AERONAUTICAL CHARTING MEETING
Charting Group
Meeting 22-02 – October 25-27, 2022

RECOMMENDATION DOCUMENT

FAA Control #22-02-375

Subject: FAA Charting depictions of stopways and blast pads

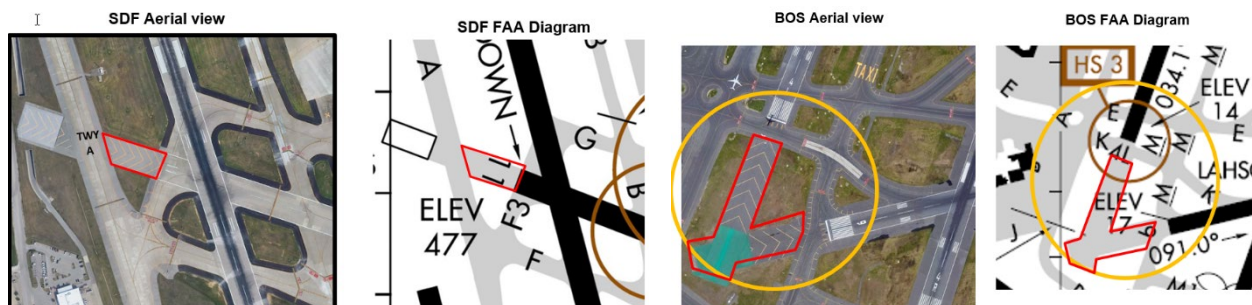
I reached out to Jeppesen to alert them about this discrepancy. Jeppesen has since agreed to correct the stopway depiction on their SDF Diagram. The stopway will now appear in accordance with their charting legend indicated in this figure:
